REQUEST FOR PROPOSAL
ADDENDUM NO. 01

TO: ALL PROPOSERS	DATE ISSUED 04-24-2026
PROJECT NAME Tin Cup Springs Equestrian Campground Improvements	FILE NUMBER 751/26123.RLO
PROJECT DIRECTOR Ronda Osga	PROPOSAL DUE DATE: APRIL 30, 2026; 2:00 PM EST

DATE: JUNE 3, 2025		DRAWN BY: IRA	
REV: AUGUST 4, 2025	PAGE 1 OF 1	JOB #526125B	
PART OF THE NW¼, NW¼, SEC. 8, T18N, R11W, PINORA TWP., LAKE CO., MICHIGAN

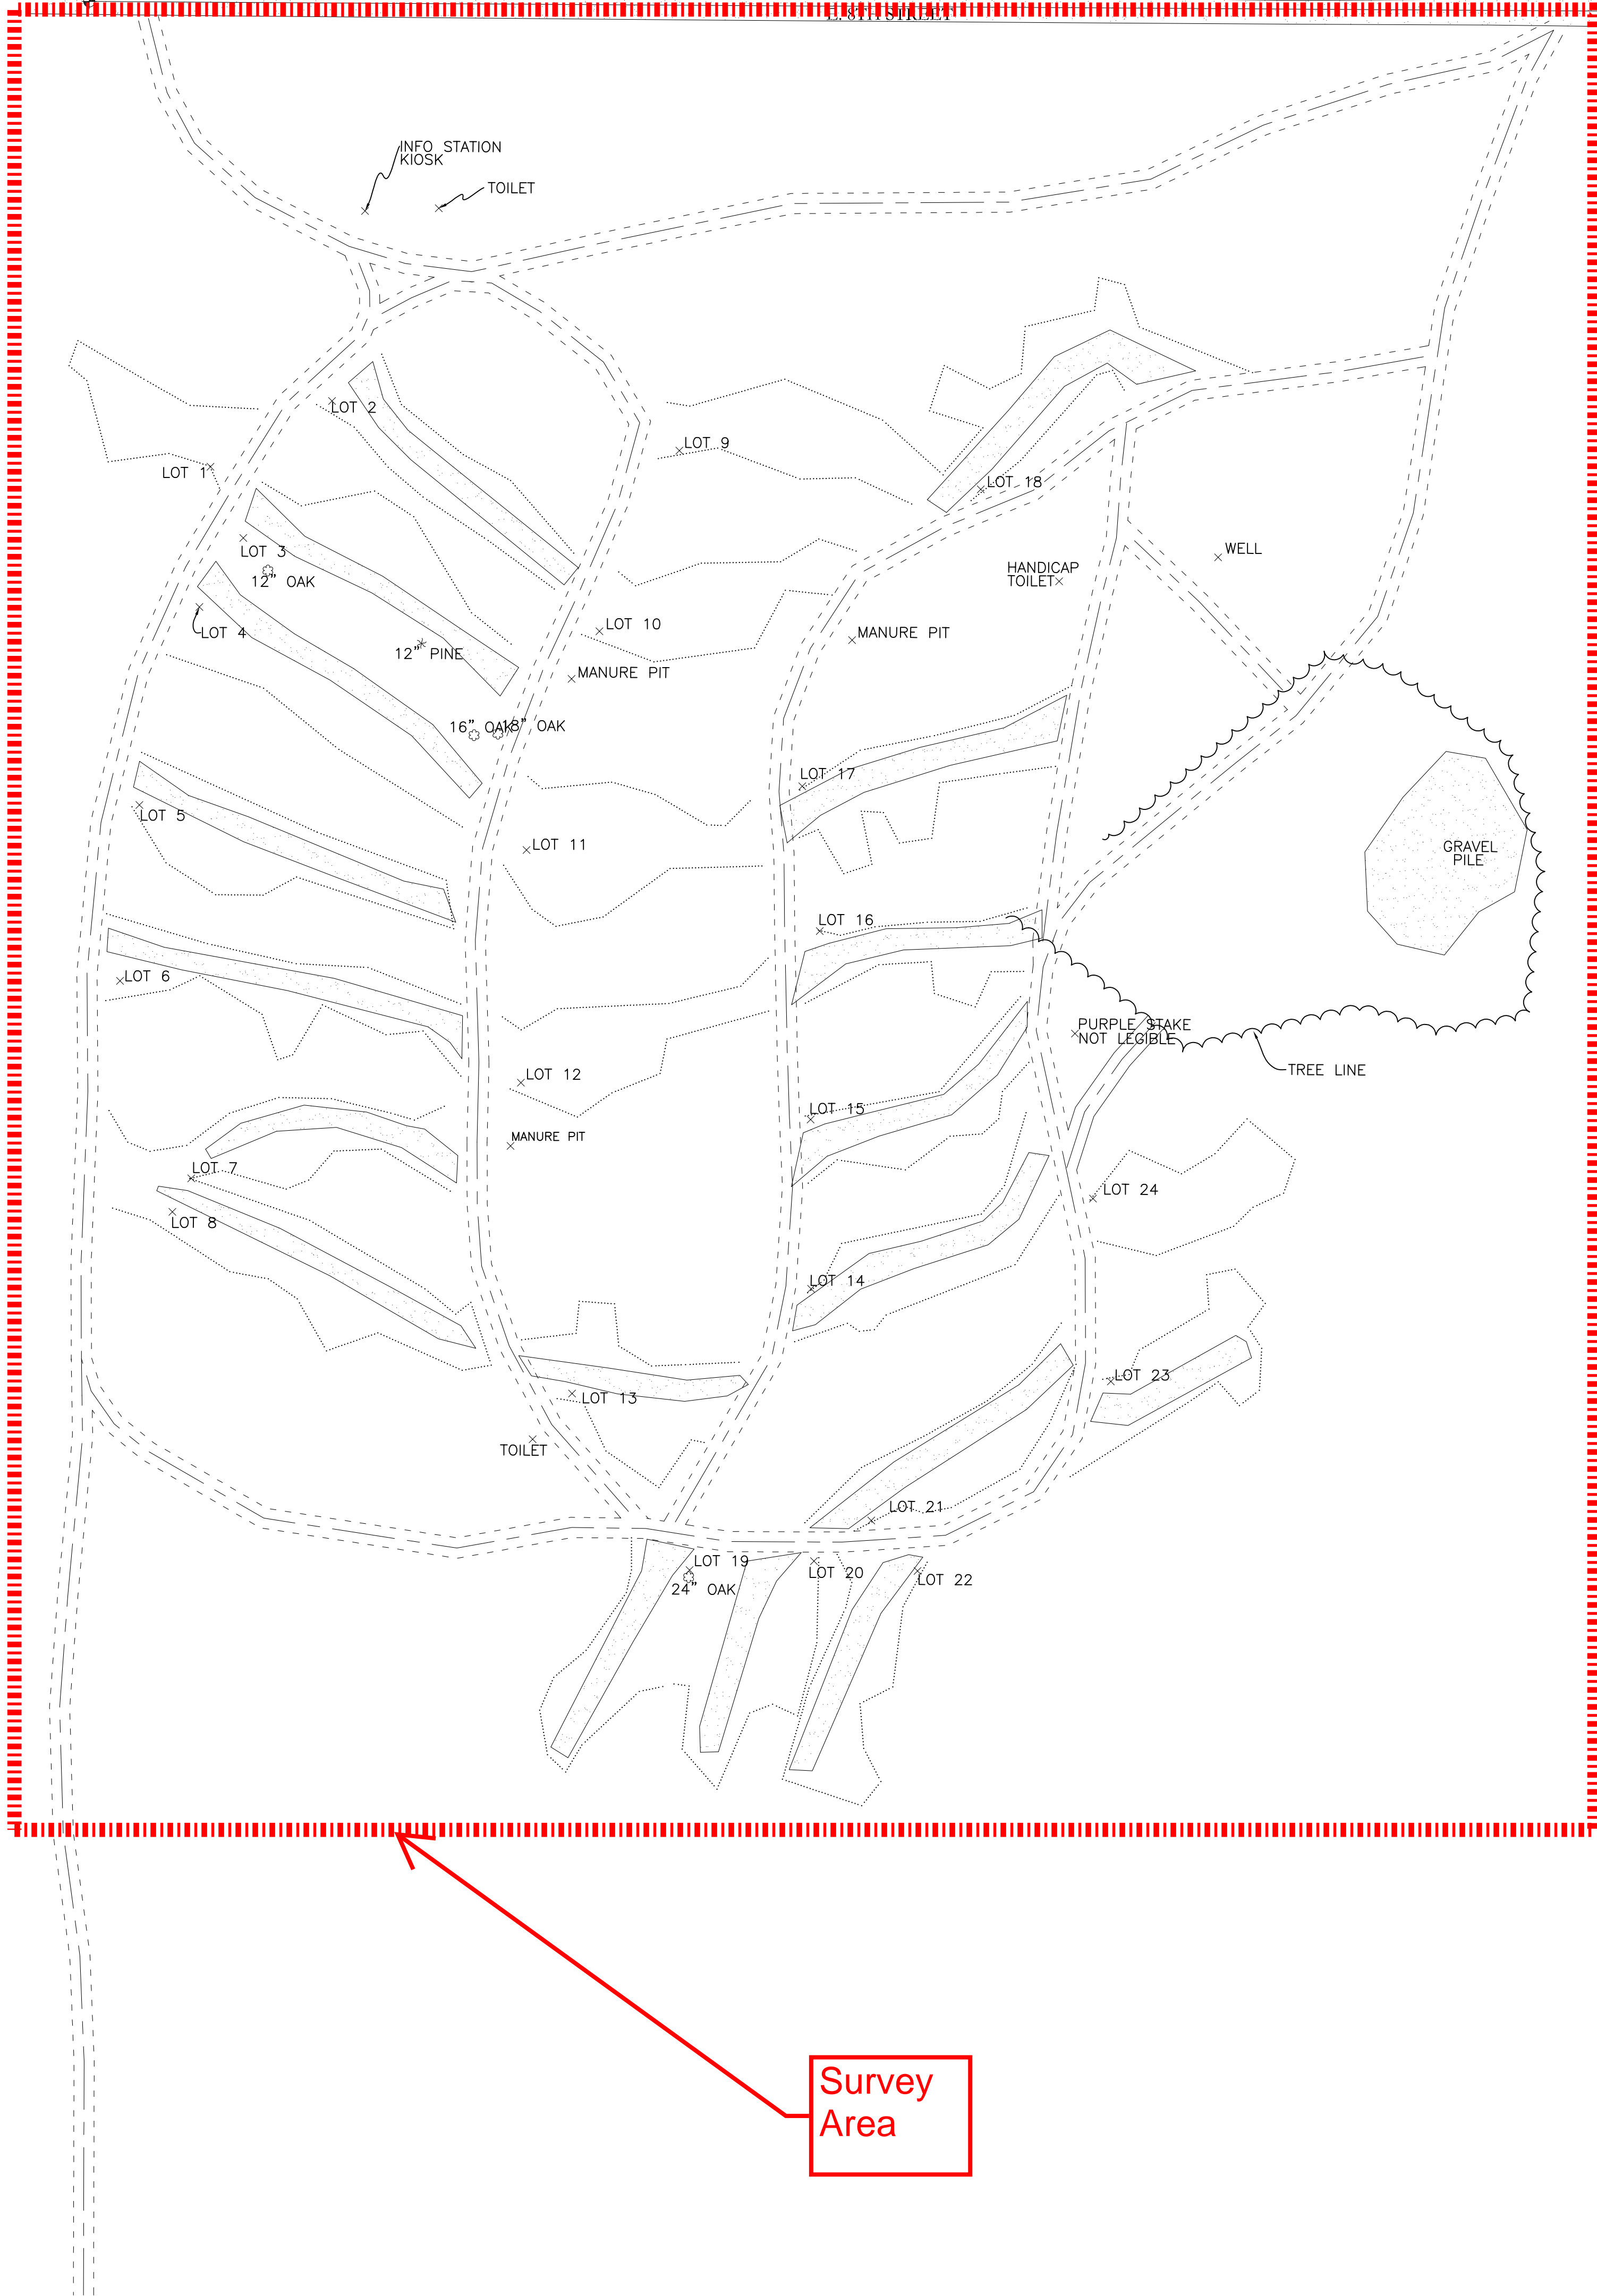
Q1- Can you verify that scope of work should include a topographic and tree survey of the project site?

R1- Include a topographic and tree survey. The survey area shall include an approximate 800-foot x 900-foot area as shown on the attached As-Built drawing.
